MEMORANDUM

UTAH DEPARTMENT OF TRANSPORTATION

SUBJECT: Standards Committee Meeting Minutes and Next Meeting

TEMPORARY WALKWAY

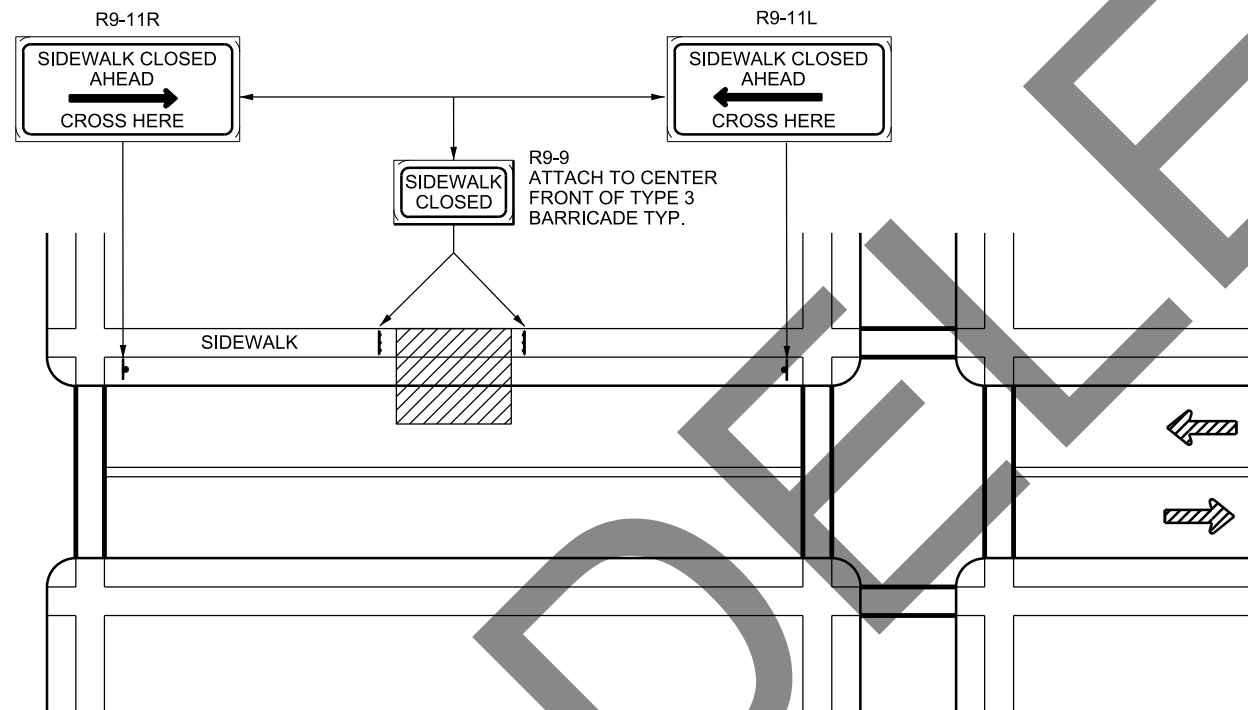
| Timestamp | Email Address | REVIEWER | DRAWING #, SECTION #, ARTICLE #, ETC. | COMMENT | RESPONSE | RESPONSE BY |
|--------------------|-----------------------|------------------|---------------------------------------|---|---|-------------|
| 9/19/2019 8:14:48 | fdoehring@utah.gov | Fred Doehring | TC 6A, Detail TC 6-1,2 | The notes called out are not correct. | TC 6-1 has been corrected to reference note 6. TC 6-2 has remove reference to note 6. | Justin W |

| 9/26/2019 12:37:44 | jcorney@utah.gov | | TC6A | Edge Treatment Detail: Delete reference to note 7. Notes 6 and 7 apply to vertical discontinuities greater than 1/2 inch. The detail does not address that condition. The reference to note 7 from the temporary ramp details covers both options. | Reference to note 7 has been deleted. Detail names changed to Vertical discontinuities and Lateral discontinuities. Update note 6 to remove Detail TC 6-1. Remove callout under detail TC 6-1. | Justin W |

TANGENT BARRIER

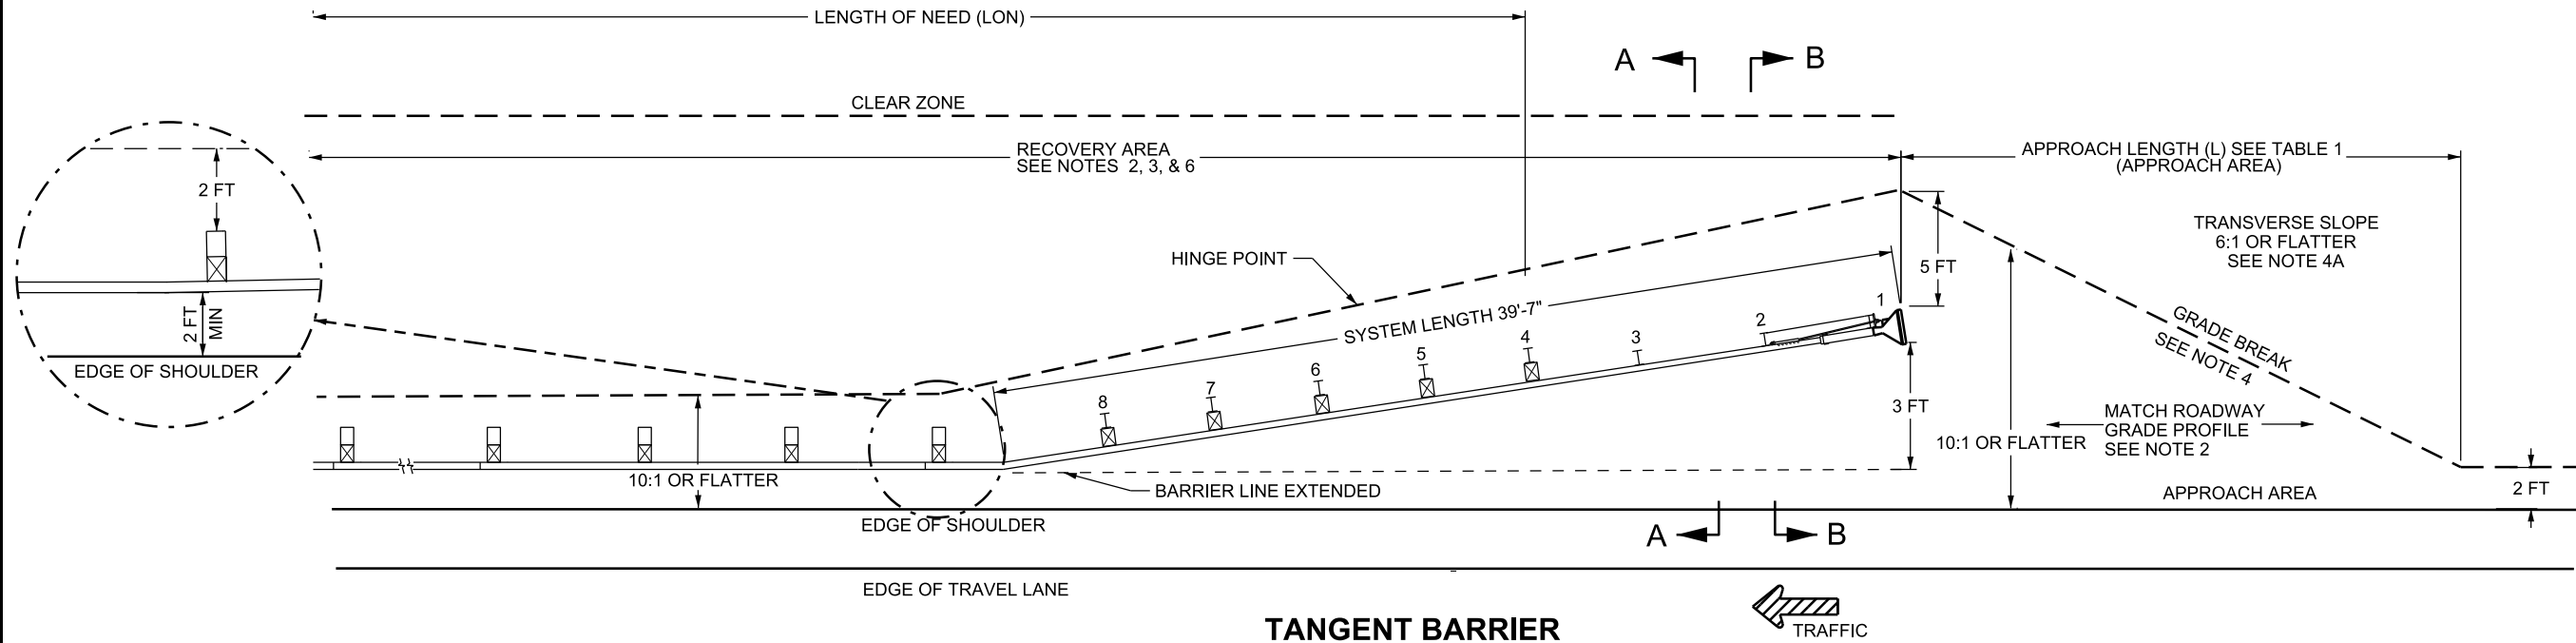
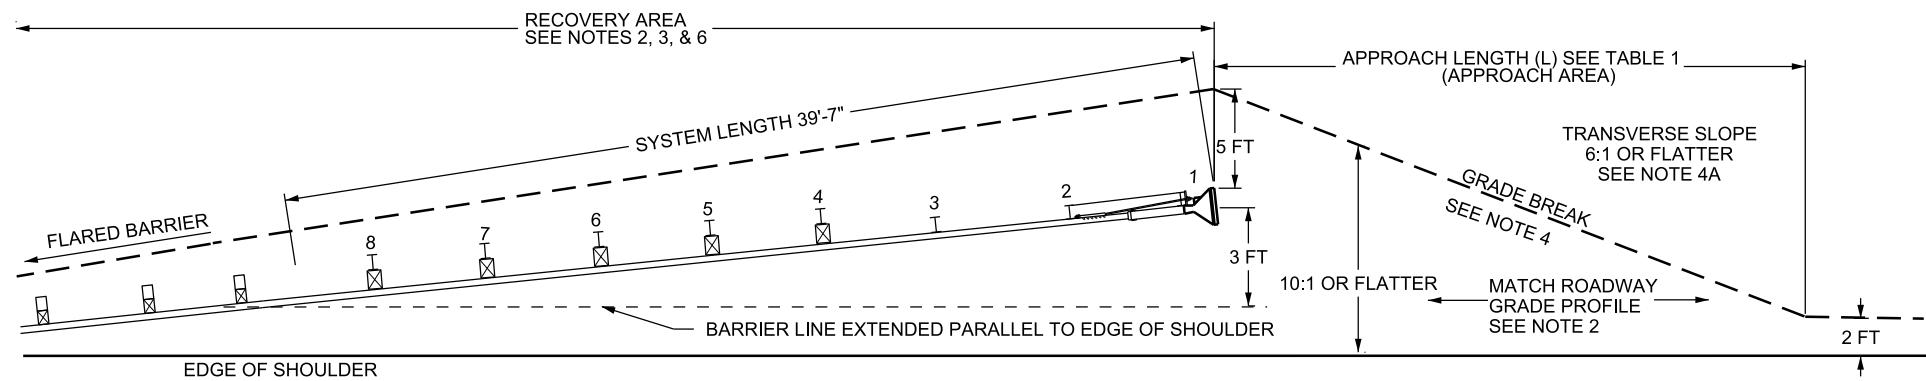
| 10/9/2019 0:17:57 | raycook@utah.gov | Ray Cook | CC 09 | Tangent Barrier detail refers to Note F which does not exist. "Notes 2" should be "Note 2." Typical Sections – Delete "Limit" from "Clear Zone" Revise Note 2: "Install system after slope preparation is complete." (Slope preparation is not part of the system installation work.) | Implemented | Shawn D. |

16-OCT-2019 D:\N_Files\Standards\Standards Committee\Meeting\11a\2019\10-October_31_2019\Incoming\Std_F_Shape_Barrier\BA1D.dgn

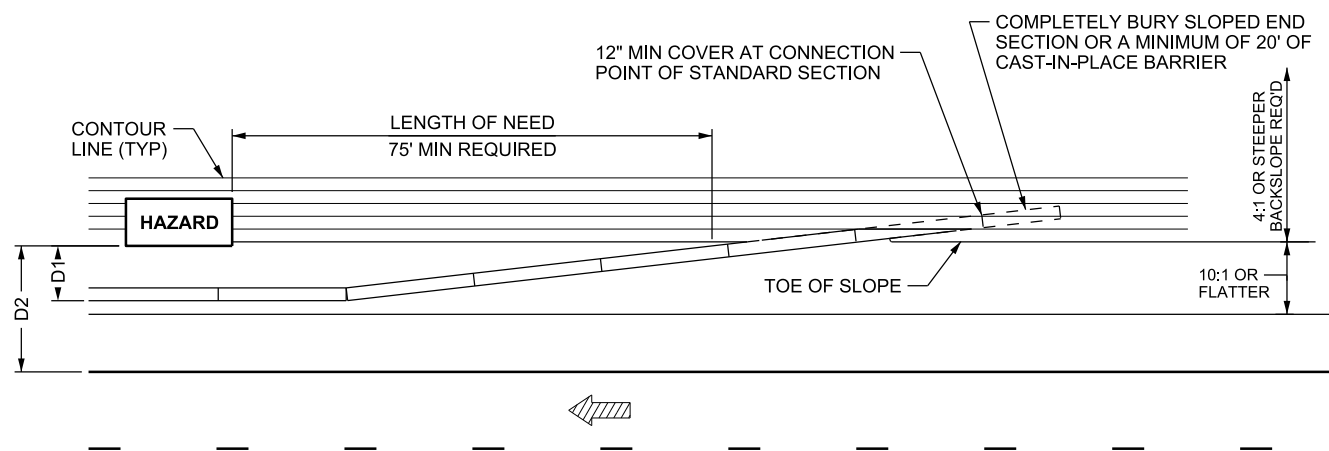
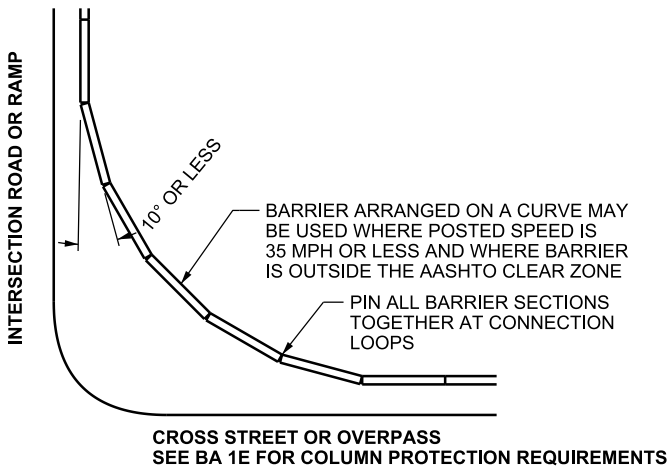
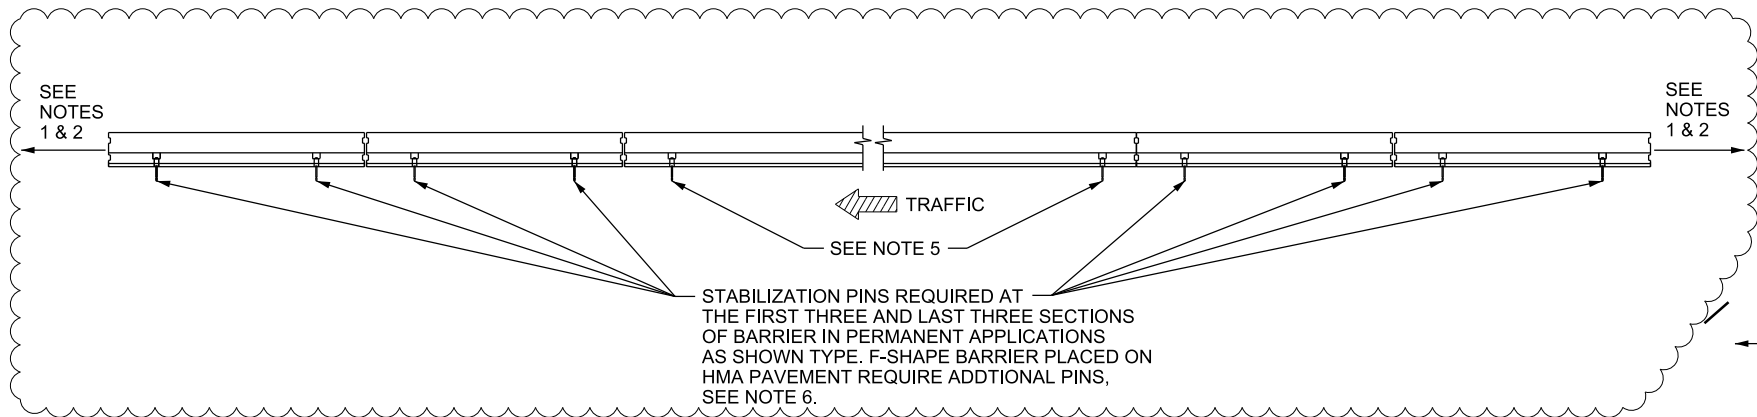
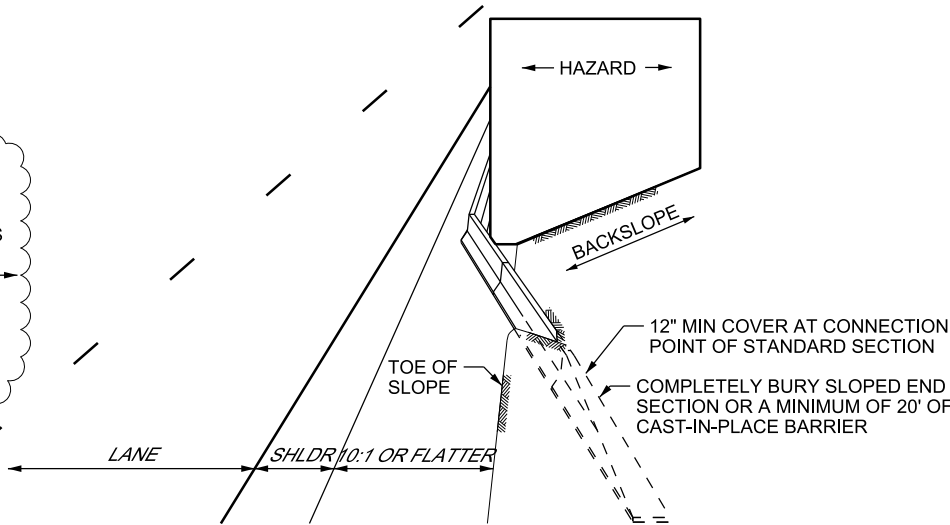
| 10/3/2019 12:32:52 | jcorney@utah.gov | | BA 1D | Note 5: Turn final sentence into new note and add pins to it "6. See STD. DWG. BA 1F2 for barrier layout and stabilization pin requirements." | Implemented | Shawn D. |

| NO. | DATE | APPR. | REMARKS |
|-----|----------|-------|--|
| 2 | 10/31/19 | SDD | MODIFIED TYPICAL ELEVATION, ADDED NOTES 5 & 6. |
